COPPERSTRING EIS

Attachment F - Vegetation Clearing Works plans

Dajarra Road Substation to Selwyn Substation

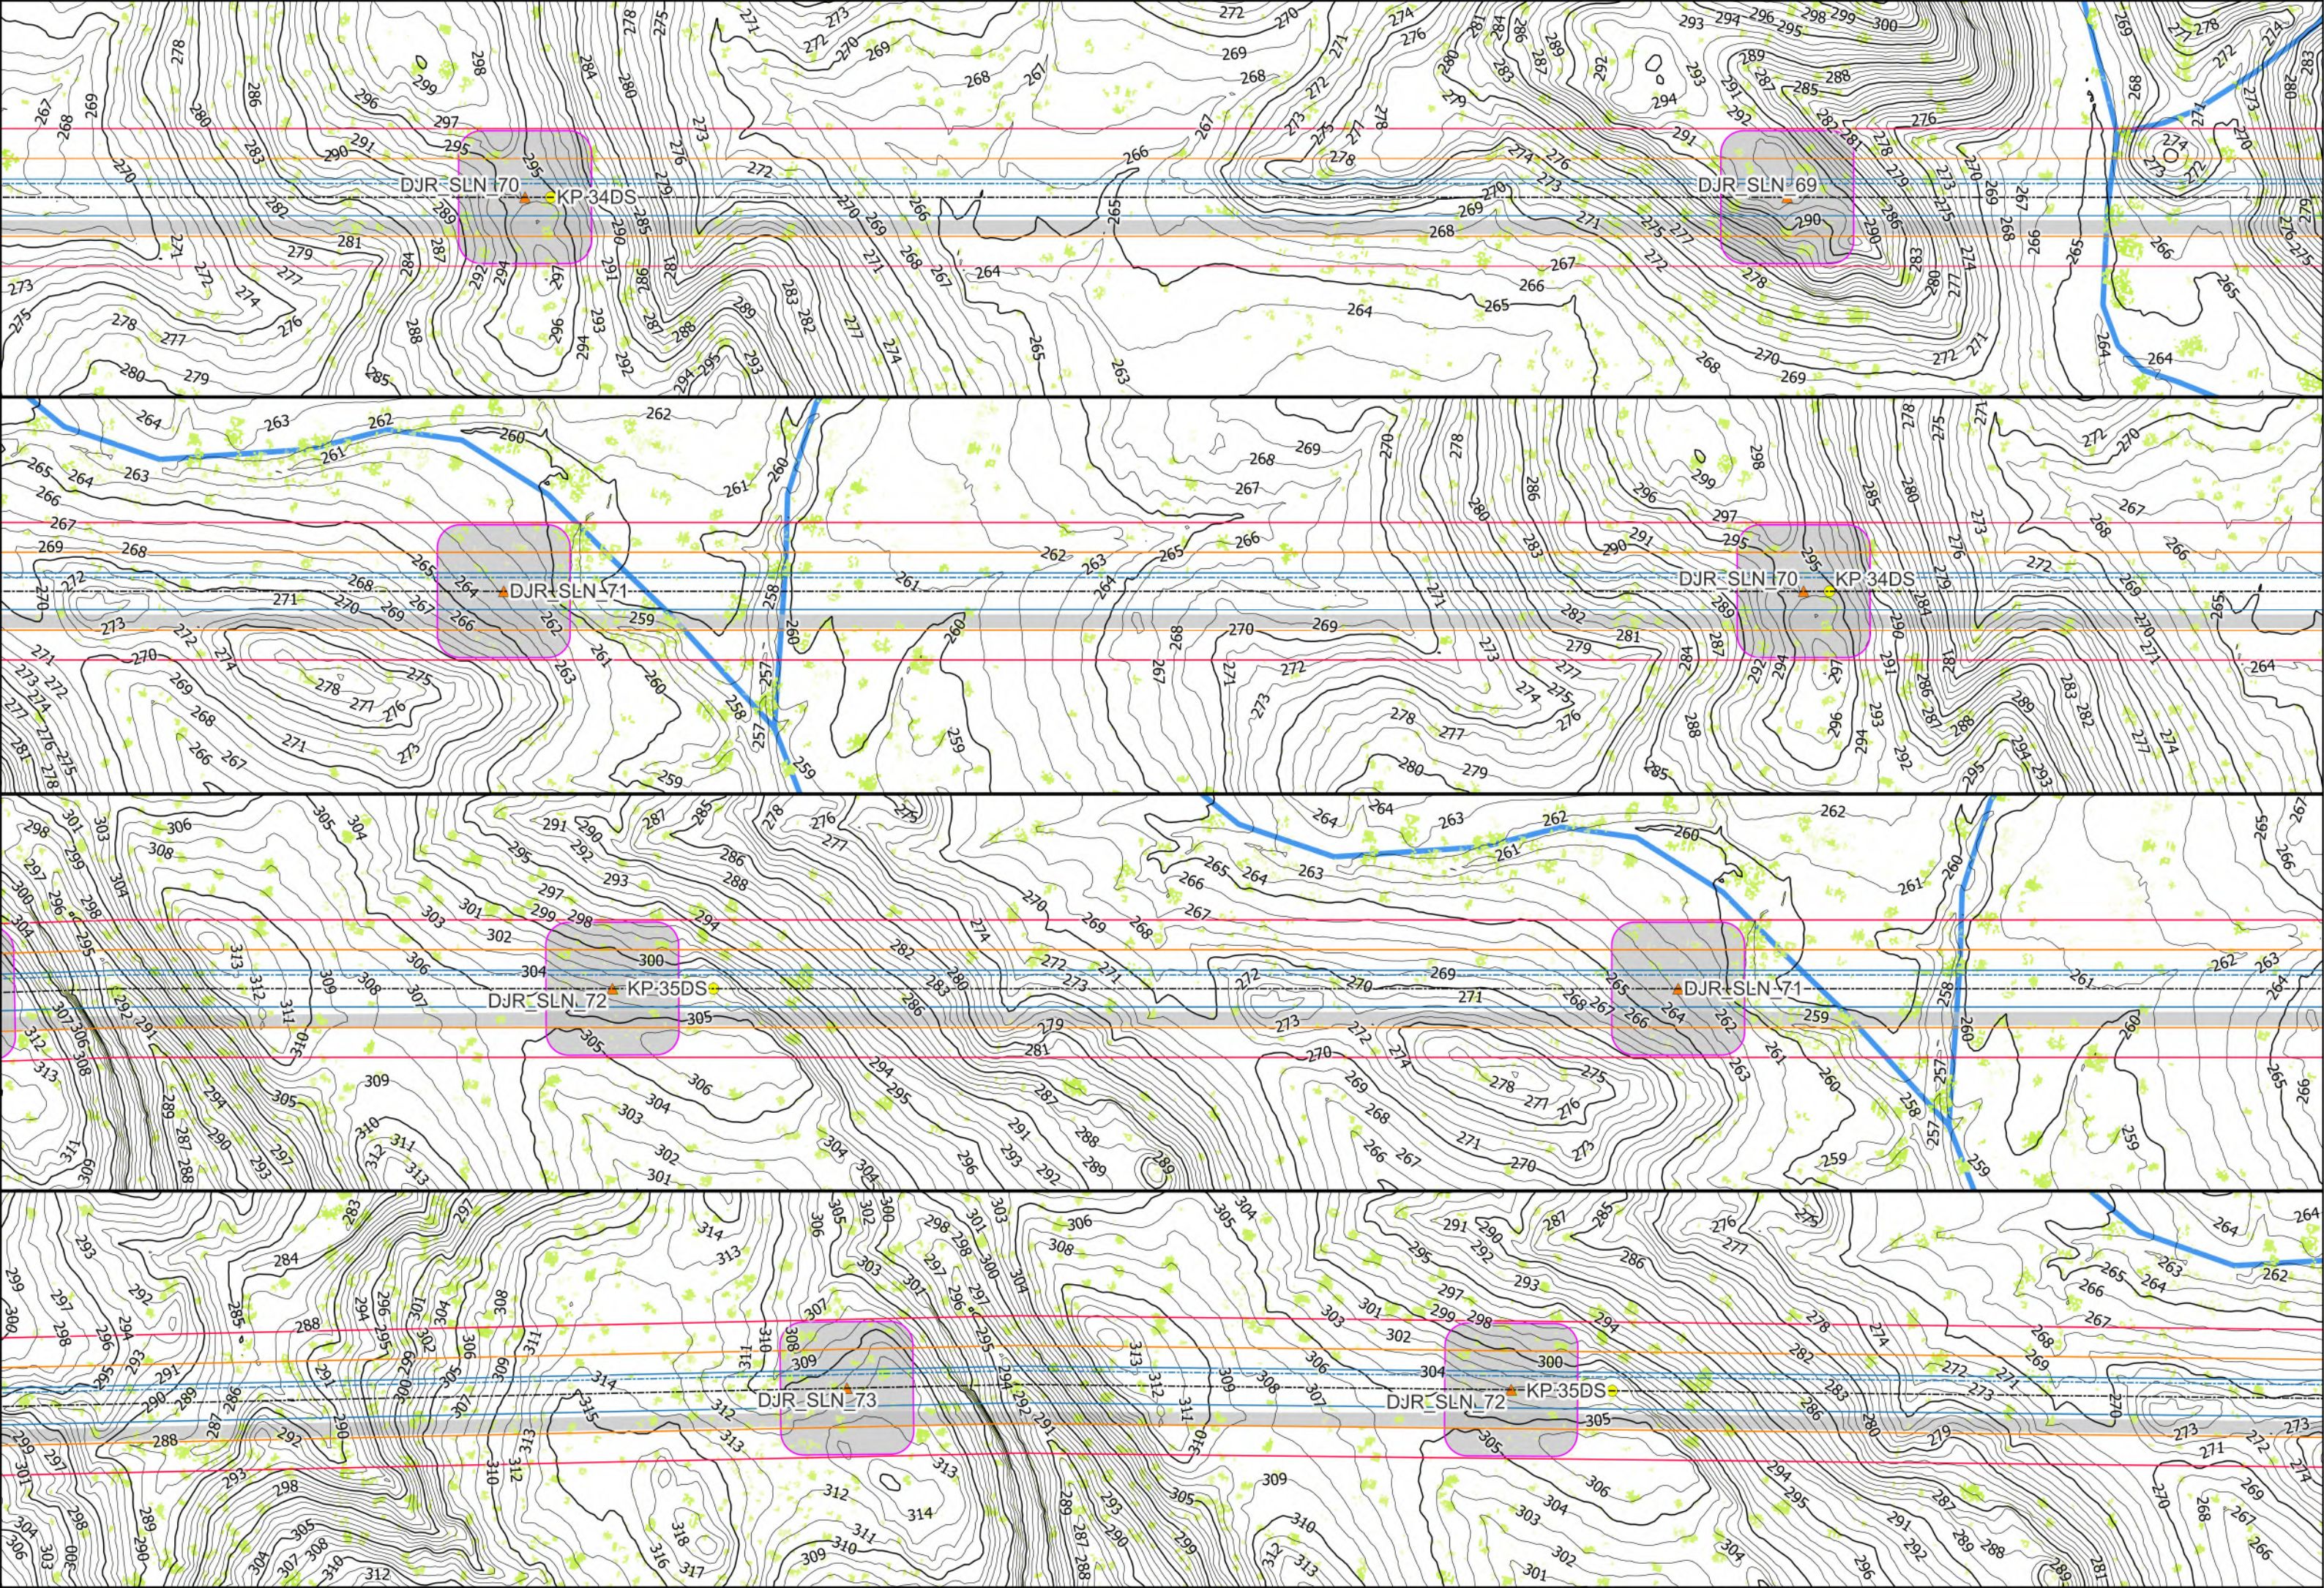
Tower assembly area to be reconfigured to not be within 15m of the high bank of waterway and to avoid clearing near or within the bed and banks for the waterway.

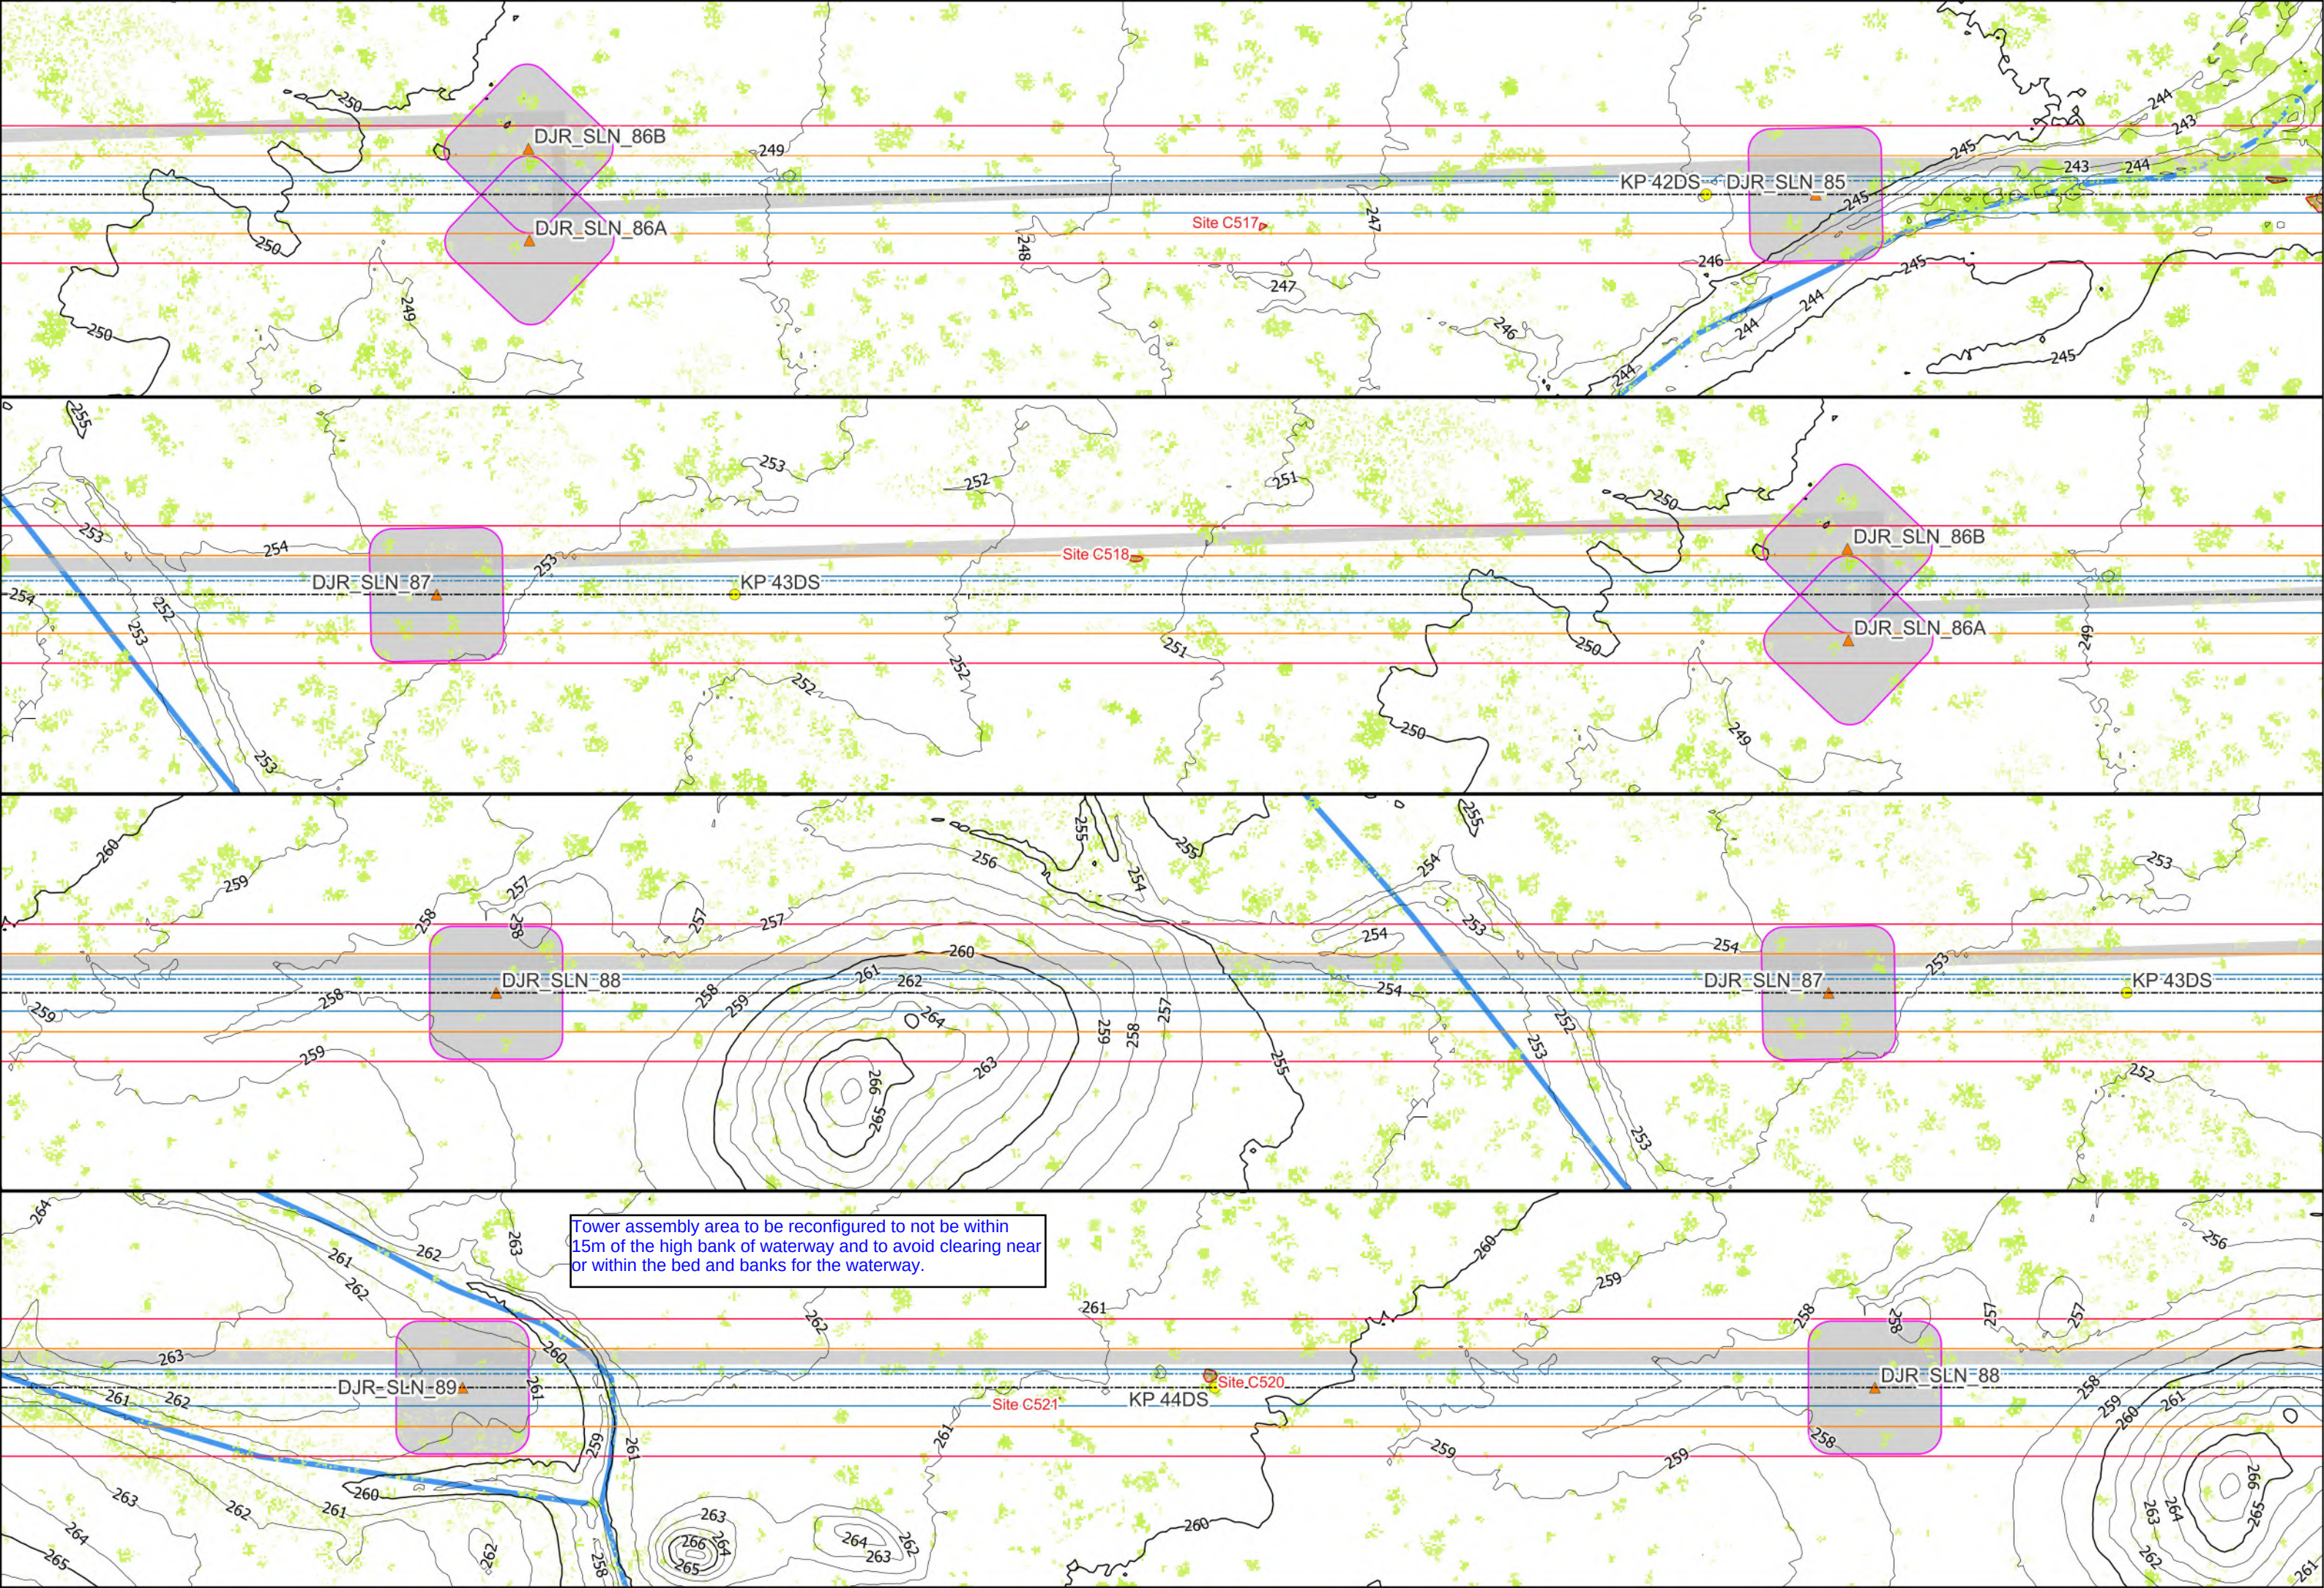
Tower height and placement to be reviewed during detailed design to reduce clearing impacts to waterway. Clearing for conductor clearance to this Major Risk (purple) waterway occur above ground level to minimise disturbance to ground and roots which contribute to bank stability.

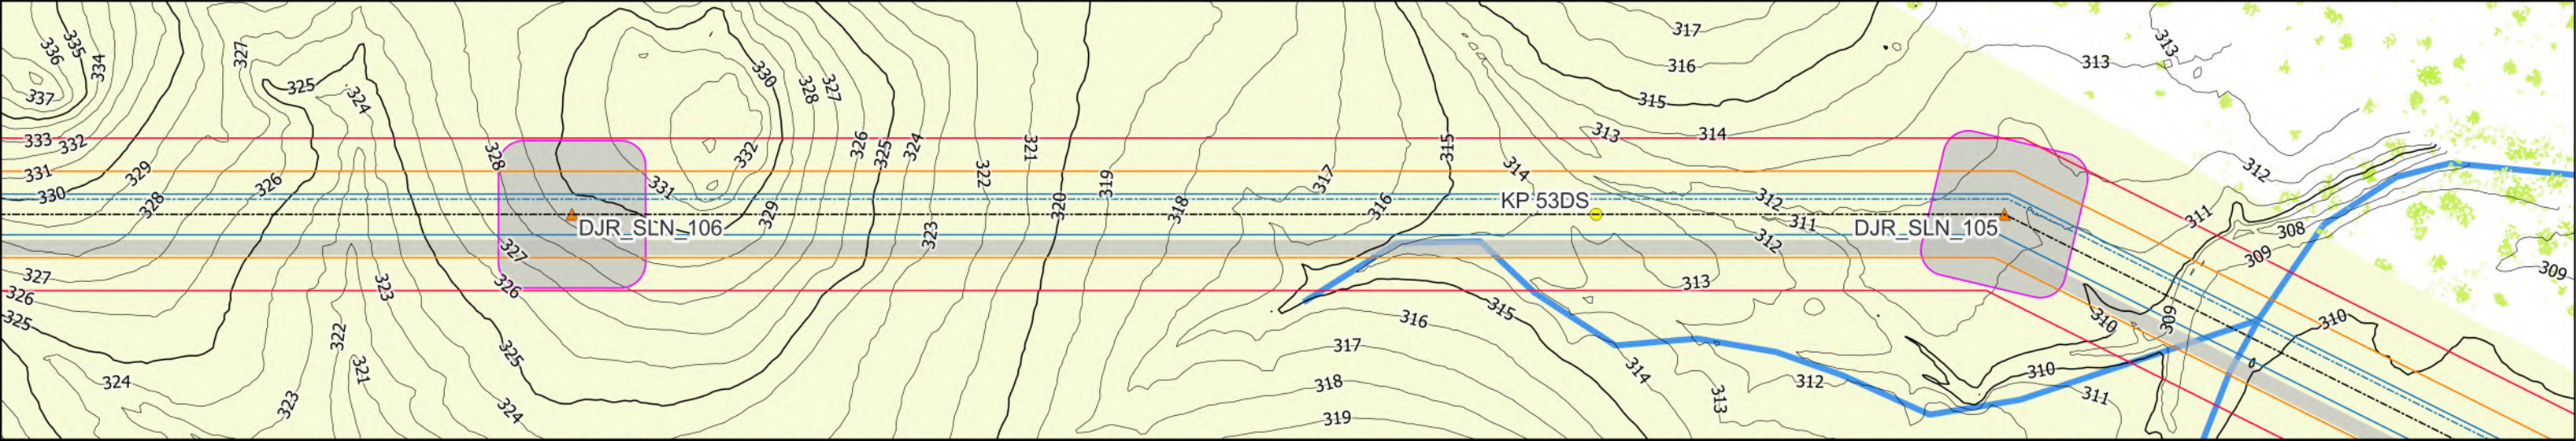
Tower assembly area to be reconfigured to not be within 15m of the high bank of waterway and to avoid clearing near or within the bed and banks for the waterway.
